1 Incorporating the V* Architecture in FC-BB-5

Figure 2 – FCoE VN_Port to VF_Port Network Configuration

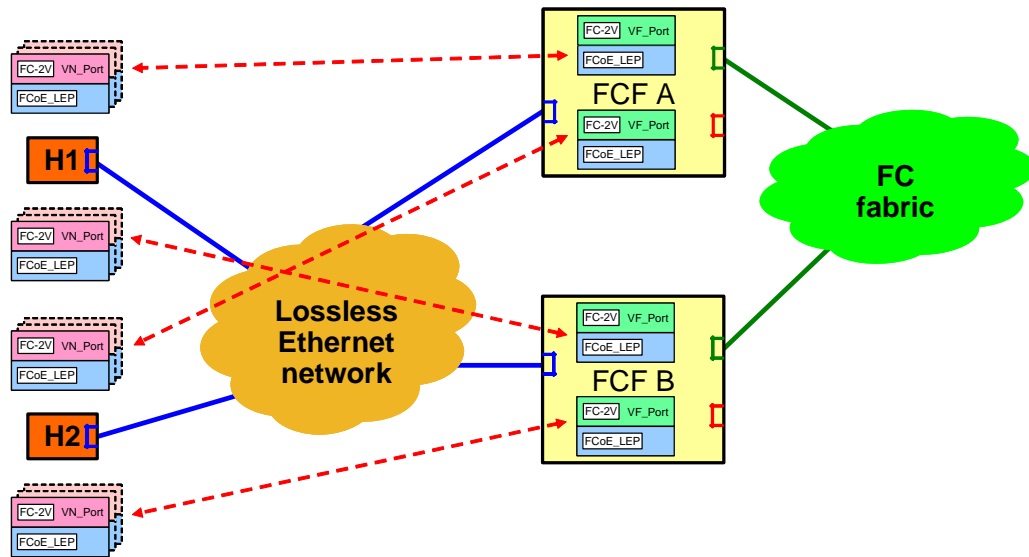
Each of the two ENodes H1 and H2 depicted in figure 2 has a single physical Ethernet connection to the Lossless Ethernet network, as well as each of the two FCFs, FCF A and B. Each ENode may instantiate multiple VN_Ports, connected to VF_Ports instantiated by the FCFs through FCoE Virtual Links. The dotted lines in figure 2 depicts possible VN_Port to VF_Port Virtual Links. In this case, a multi-access Lossless Ethernet network is reduced by FCoE to a set of point-to-point VN_Port to VF_Port Virtual Links where the ~~N_Port-VN_Port~~ to ~~F_Port-VF_Port~~ Fibre Channel protocols are able to operate unchanged.

Figure 3 – FCoE VE_Port to VE_Port Network Configuration

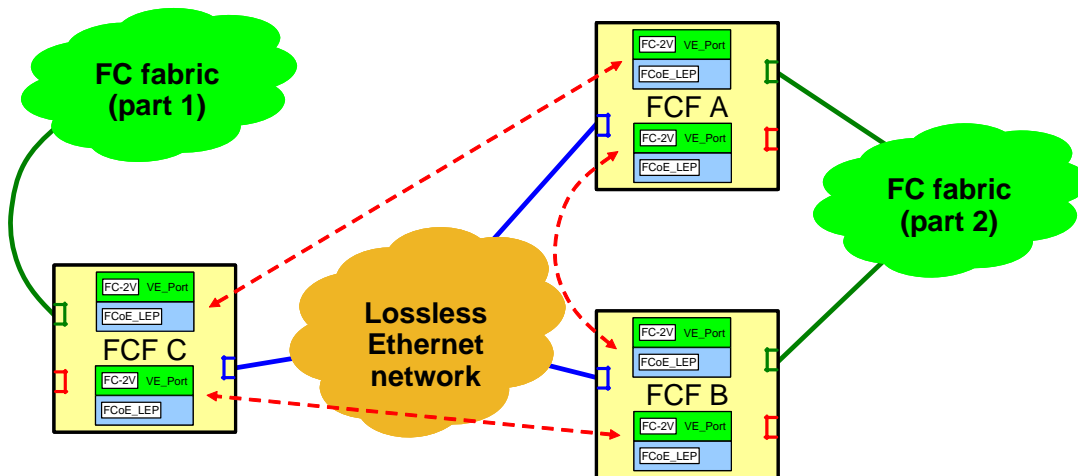
Each of the three FCFs A, B, and C depicted in figure 3 has a single physical Ethernet connection to the Lossless Ethernet network. Each FCF may instantiate multiple VE_Ports, connected to other VE_Ports through FCoE Virtual Links. The dotted lines in figure 3 depicts possible VE_Port to VE_Port Virtual Links. In this case a multi-access Lossless Ethernet network is reduced by FCoE to a set of point-to-point VE_Port to VE_Port Virtual Links where the E_Port-VE_Port to E_Port-VE_Port Fibre Channel protocols are able to operate unchanged.

Figure 5 – FC_BB_E VE_Port/VF_Port functional model

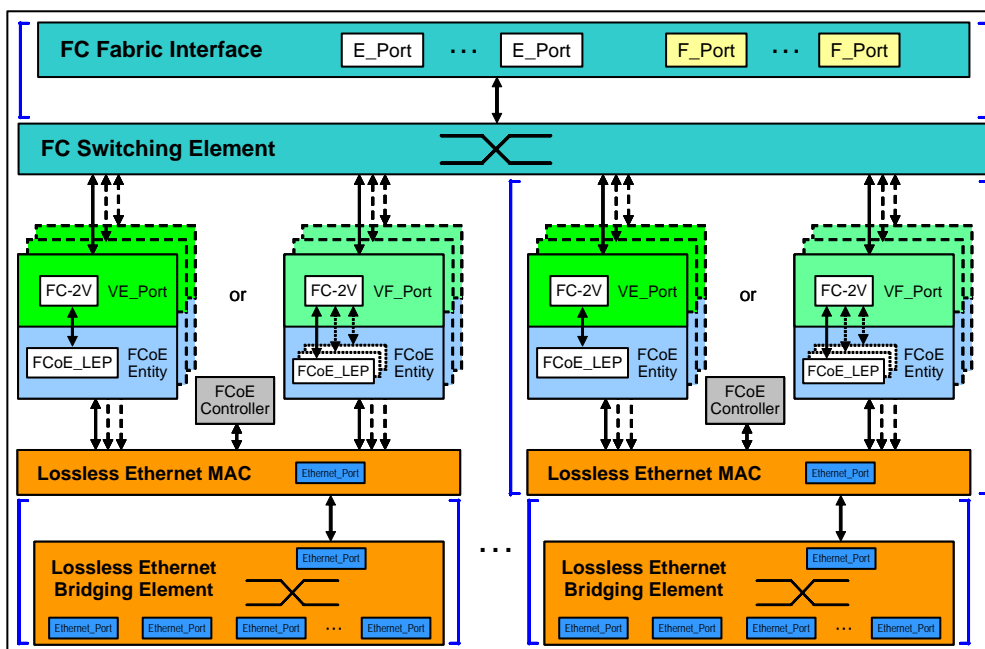
~~Editor's Note: The Lossless Ethernet Bridging Element should not be part of the VE_Port/VF_Port functional model.~~

An FCF-MAC shall support the instantiation of VE_Ports and/or VF_Ports. An FCF-MAC supporting the instantiation of VE_Ports is referred to as a VE_Port capable FCF-MAC. An FCF-MAC supporting the instantiation of VF_Ports is referred to as a VF_Port capable FCF-MAC. Support for An FCF-MAC shall not support both VE_Ports and VF_Ports on the same FCF-MAC is allowed, but not recommended concurrently.
